SUBJECT: ADMINISTRATIVE HEARING ON A PERMIT APPEAL OF THE PLANNING COMMISSION'S APPROVAL OF A CONDITIONAL USE PERMIT AND SITE DEVELOPMENT PERMIT (FILE NO. CP16-035)

The purpose of this Supplemental Memorandum is to provide the Council with information on the updated noise and traffic studies.

Subject: File No. CP16-035

To: Tony Andary
From: William Rosental
Mei Wu
Date: December 4, 2017
Subject: Andoil Bascom Car Wash Noise Study
MWA Project – 15059C

Figure 3: Proposed Noise Barriers (Red Lines, labelled by Red Boxed Numbers) and Receiver Locations (Blue Boxed Numbers)

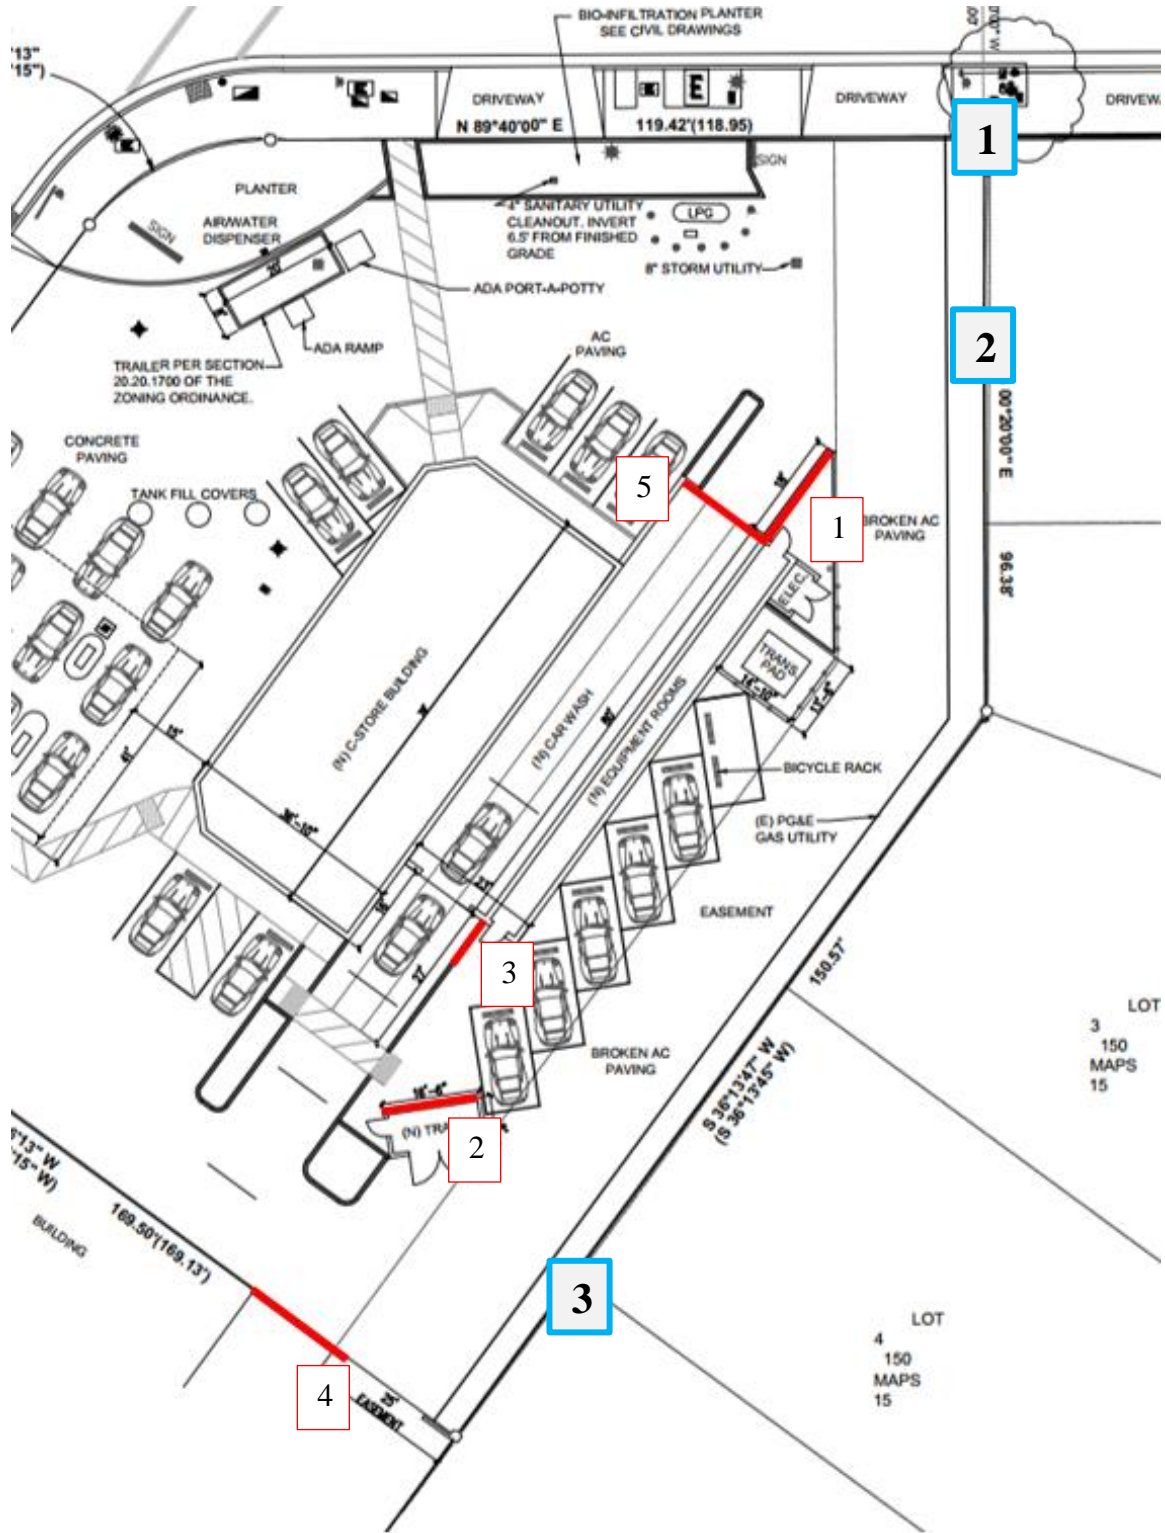
Sound barriers will be utilized to reduce the noise levels at the property planes. These barriers will be monolithic (without any major holes or gaps) and will be constructed of materials that satisfy the requirements for acoustics barriers.

The following five noise barriers are proposed to bring the project into compliance with the policies of the San Jose General Plan and Municipal Code:

1. The project plans the construction of an 18 ft long, 12 ft high barrier at the exit of the carwash, blocking the eastern property line.
2. A trash enclosure will be constructed to conceal the dumpster onsite. This enclosure will be 12 ft tall, 16' 6" in length and positioned such that it breaks the line of sight from the carwash entrance to one of the residential properties to the southeast. This barrier will provide insertion loss for receivers to the southeast.

5. A 12 ft tall, retractable vinyl sound shield (equivalent to the Airlift XRS series) will be installed at the exit façade of the carwash. This shield will deploy during dryer operation and fully shield the eastern property line. The surface density of the vinyl shall be no less than 1 lb/sqft² to provide adequate transmission loss to serve as an acoustic barrier.

Based on the project applicant's updated noise report and appellant's noise report, staff recommends adding a condition of approval requiring the quieter dryer, vinyl sound barrier, and 12 foot soundwall, which will allow the project to meet the Zoning Code and General Plan noise requirements.

Figure 2: Carwash and Noise Barrier Layout

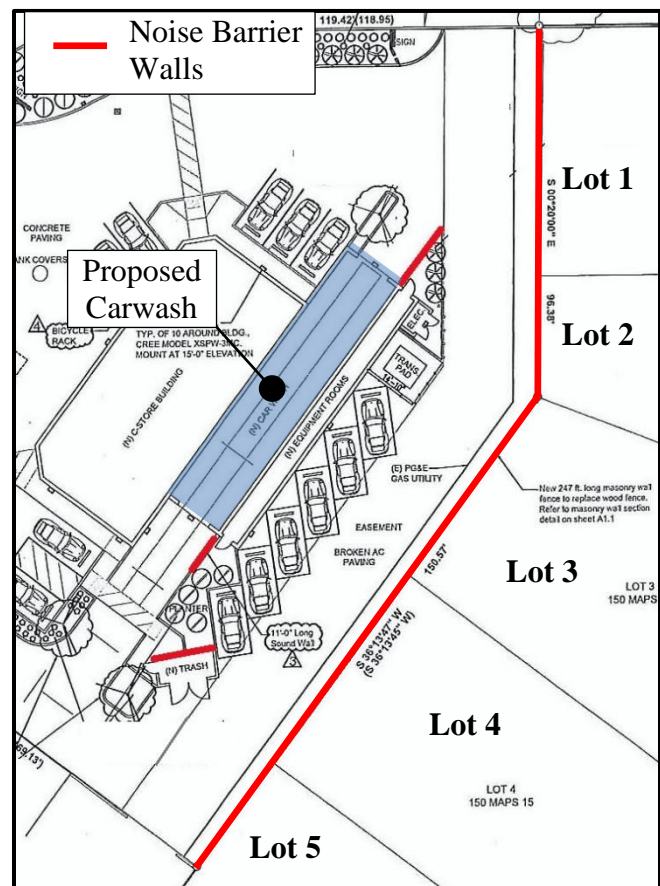
The project drawings along with the prior Noise Assessment indicate that the project will include the construction of an 18-foot long, 10-foot high noise barrier at the carwash exit, an 8-foot tall 16'-6" long masonry trash enclosure wall and an 11-foot long, 10-foot high noise barrier at the carwash entrance to reduce carwash noise emissions. Project drawings also show that the existing residential property line fence will be replaced with a 247-foot long 6-foot high masonry wall. Though this wall was not analyzed in the prior noise assessment,

it may also be effective in reducing car wash noise at the adjacent residential uses. Figure 2 shows the carwash layout and noise barrier/masonry wall arrangements relative to surrounding properties.

As situated on the site the entrance opening will be as close as 50 feet from the property line shared with residential Lot 4 and the exit opening will be as close as 40 feet from the property line shared with residential Lot 1, as identified in Figures 1 and 2.

Figure 3: Noise Modeling Locations

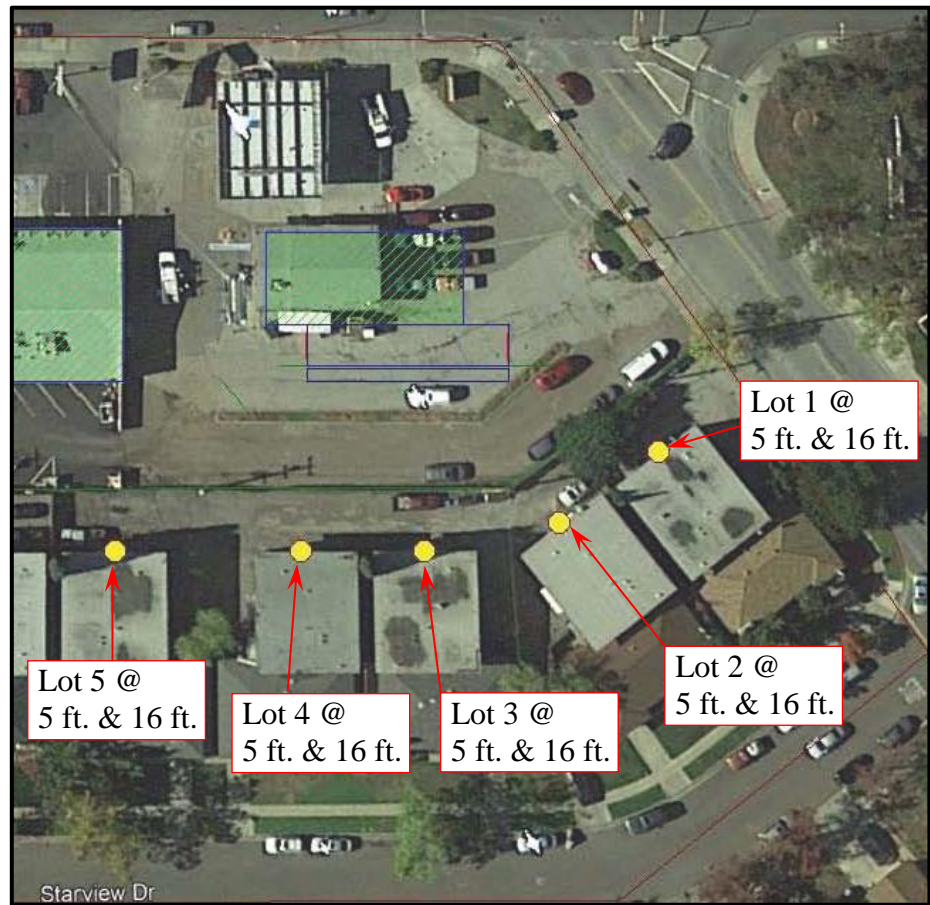
A review of noise modeling results shows that the maximum noise levels due to the operation of the proposed carwash will exceed the City’s zoning code limit of 55 dBA at the upper and lower level facades of the homes on Lots 1, 2, 4, and 5 for all analyzed car wash systems. The maximum noise levels at the home on Lot 3 will be at or below the City’s maximum noise limit of 55 dBA at the lower level facades for all analyzed car wash systems, higher noise car wash systems would also exceed the City’s maximum noise limit of 55 dBA at the upper level façade of this home⁵.

**Chart 3a: Average (Leq) Noise Levels
 2nd Level Lot 1 Residential Facades with & without car wash noise**

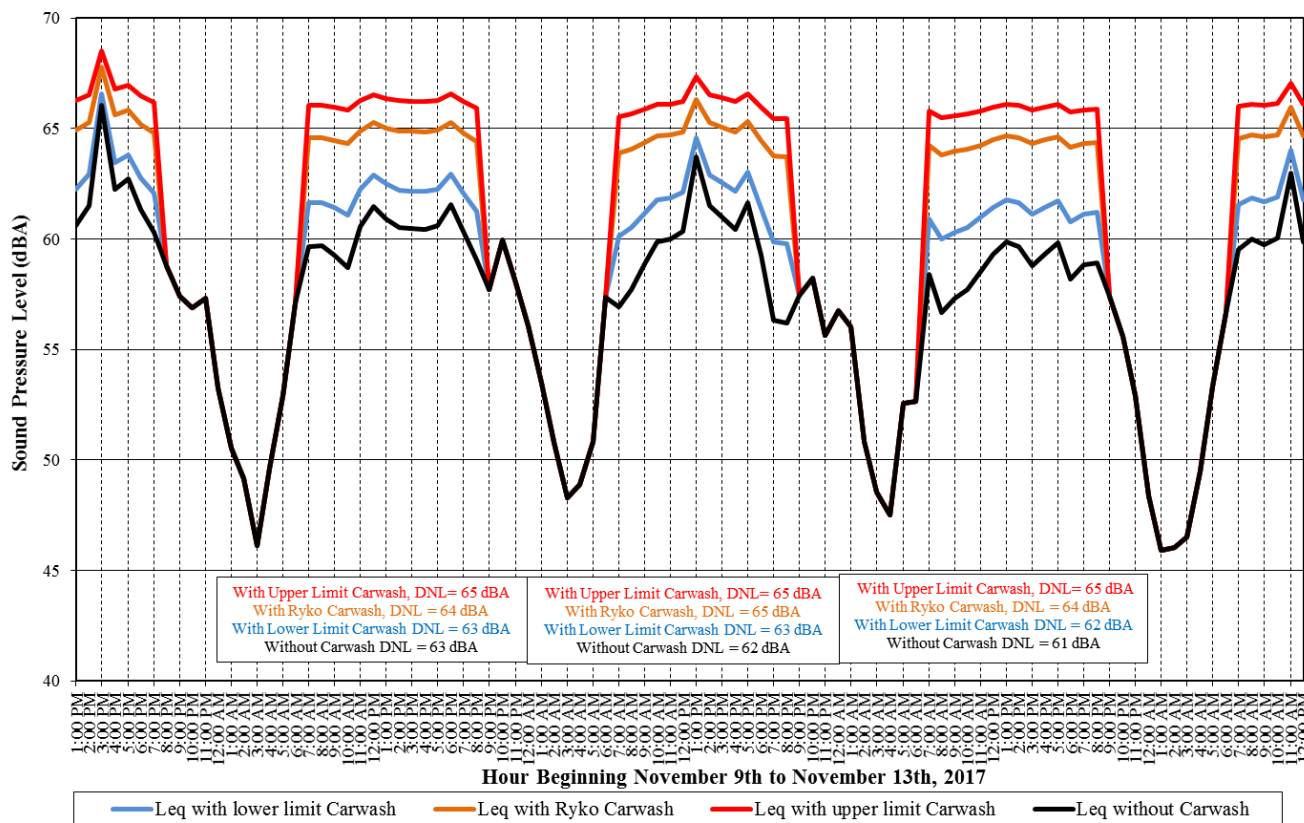
A review of Chart 3a shows that the average daytime noise levels at the upper floor facades of the residence on Lot 1 will increase due to carwash operations by between 2 to 9 dBA depending on the time of day and car wash system used. Due to these average noise level increases the DNL levels at this home will also increase, such that;

1. The lower noise level carwash system would increase the DNL measured on the Friday, Saturday and Sunday by 1 dBA,
2. The previously analyzed (Ryko) carwash system would increase the DNL measured on the Friday, Saturday and Sunday by 2, 2, and 3 dBA, respectively, and
3. The upper noise level carwash system would increase the DNL measured on the Friday, Saturday and Sunday by 3, 3, and 4 dBA, respectively.

These results indicate that the operation of either the previously analyzed Ryko carwash or the higher level carwash system analyzed would cause the DNL at the noise sensitive receptor on Lot 1 to increase by three dBA DNL or more in violation of General Plan policy EC-1.2.

**Chart 3b: Average (Leq) Noise Levels
 2nd Level Lot 2 Residential Facades with & without car wash noise**

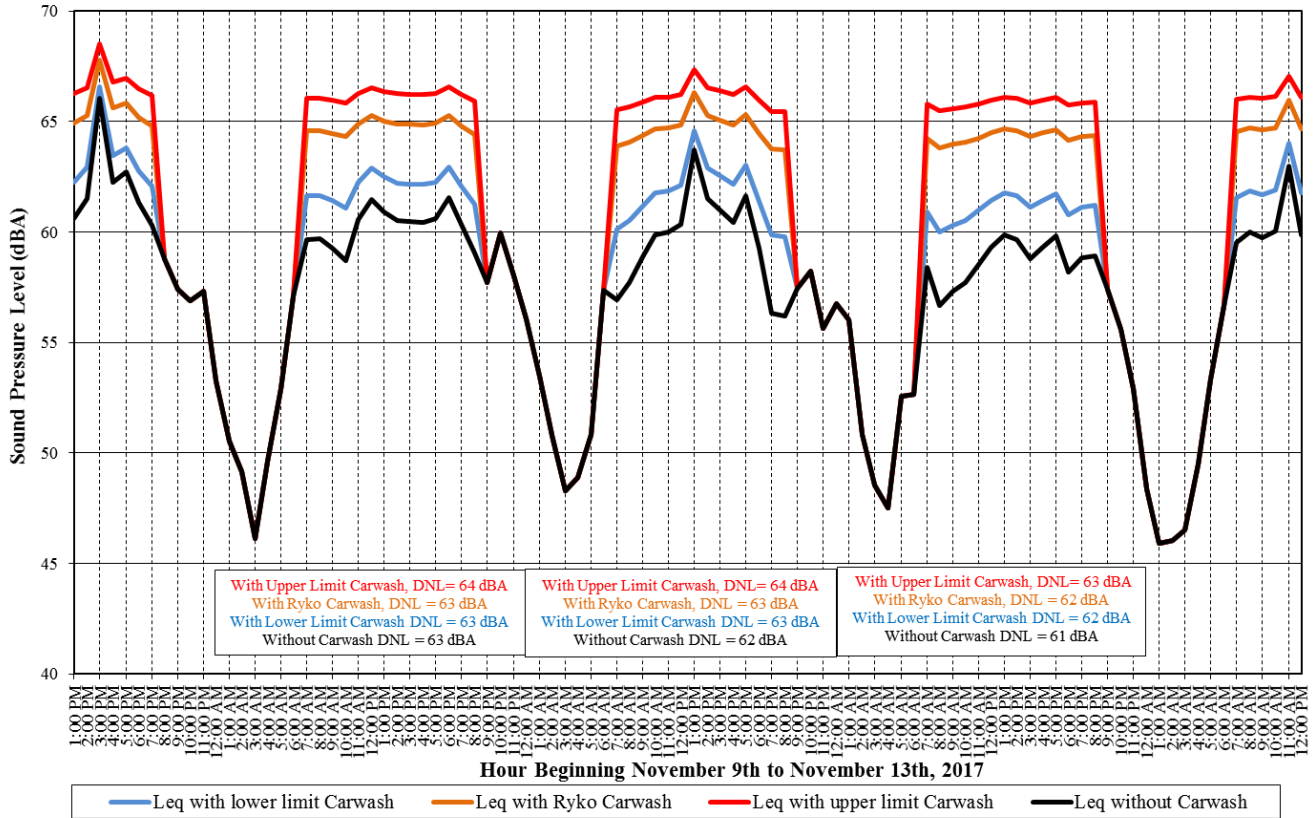
A review of Chart 3b shows that the average daytime noise levels at the upper floor facades of the residence on Lot 2 will increase due to carwash operations by between 1 to 5 dBA depending on the time of day and car wash system used. Due to these average noise level increases the DNL levels at this home will also increase, such that;

Considering the results of the above analysis for the homes on Lots 1 and 2 in combination with a review of the Carwash only DNL levels presented in Table 4, we would expect that the increase in the existing DNL due to car wash operation will be less than 3 dBA at the residence on Lots 3, 4, and 5. However as noted above, the operation of either the previously analyzed Ryko carwash or the higher level carwash system analyzed would cause the DNL at the noise sensitive receptor on Lot 1 to increase by three dBA DNL or more in violation of General Plan policy EC-1.2.
